## CERTIFICATE OF APPROPRIATENESS

**Property:** 8815 Dover Street, Lot 4, Block 55, Glenbrook Valley Section 9 Subdivision. The property includes a historic 2,404 square foot, one-story wood frame single-family residence and attached garage situated on a 7,150 square foot (65' x 110') interior lot.

**Proposal:** Alteration – Windows.

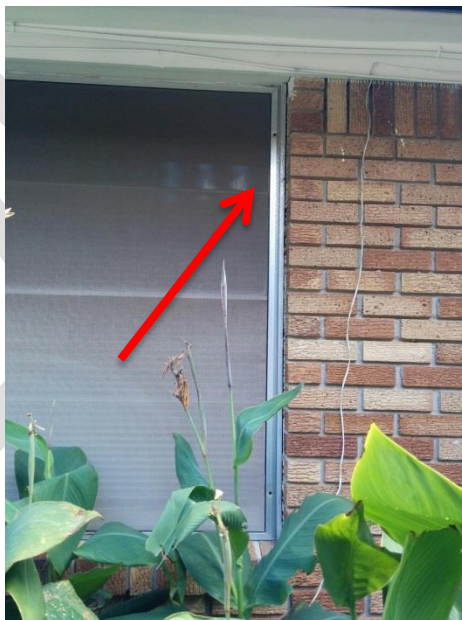
*Window C Interior: Differential settlement has caused separation of the window from the structure. This window is no longer operable.*

*Window C Exterior: Differential settlement has caused separation of the window from the structure. This is evidenced by the gap as well as the displaced brick.*

*Window F Exterior: Differential Settlement has caused the separation of the window frame from the building.*

**Recommendation:** **Partial Approval: Approval to replace B,C,D,E,F,G,H,I. Work with staff to find appropriate replacement windows.**

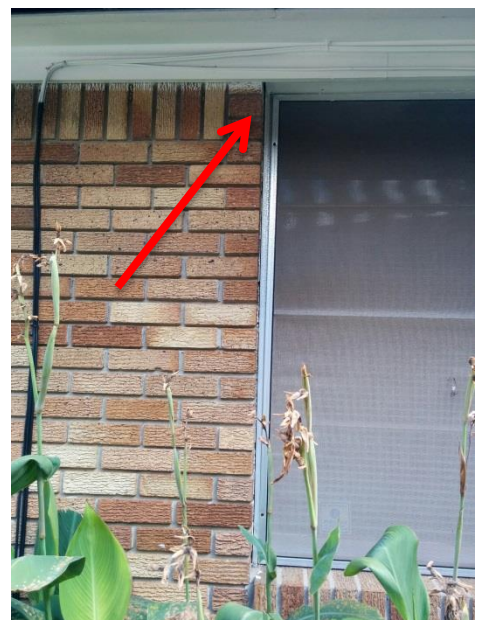
*Window I Exterior: Evidence of foundation failure that has led to the window wracking out of square and being rendered inoperable.*

*Window H Exterior: Differential settlement has caused the window to separate from the structure.*

*Window H Exterior: Differential settlement has caused the window to separate from the structure.*
